SERVICE BULLETIN

Exchange of floats (pair) on ROTAX® Engine Type 912, 914 and 2-stroke (Series)

SERVICE BULLETIN**Exchange of floats (pair) on ROTAX® Engine Type 912 and 914 (Series)**

Fig. 3

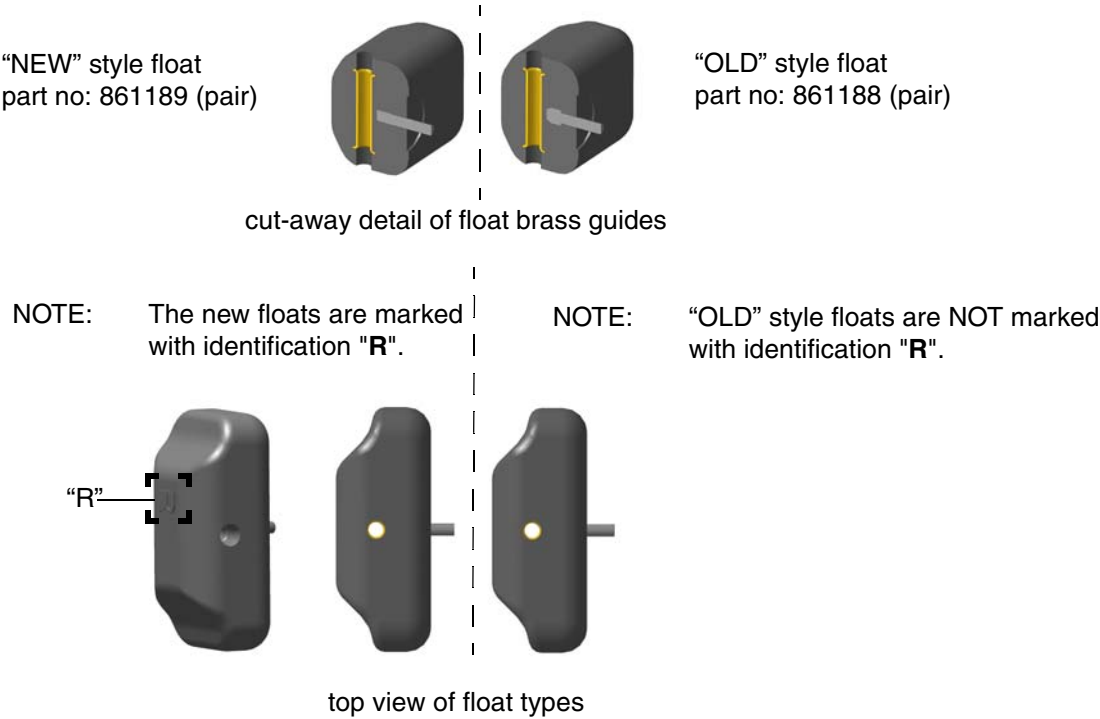
Due to a deviation in the manufacturing process some floats of part no. 861185 and part no. 861188 could gain more weight. This leads to a loss of float buoyancy and wrong regulation of the fuel in the float chamber. Possible effects may be a rough running engine, especially at low speeds and under some circumstances loss of performance and/or fuel leakage in the area of the carburetor. Above mentioned floats must be replaced with floats part no. 861189.

NOTE: For carburetors, service kits carburetor, maintenance kit carburetor, overhaul kit etc. replace affected floats part no. 861185 and 861188 with floats part no. 861189 (see [Fig. 3](#)).

Perform visual inspection of style of float (see Fig. 3).

Style of float	Procedure
“NEW” style float part no. 861189 (pair)	Do not need to be changed and can be reused; go to section 3.5.4.
“OLD” style float part no. 861185 or part no. 861188 (pair)	- Exchange of the floats must be carried out according to the latest Maintenance Manual Heavy (MMH) - Replace them with part no. 861189 and go to section 3.5.4
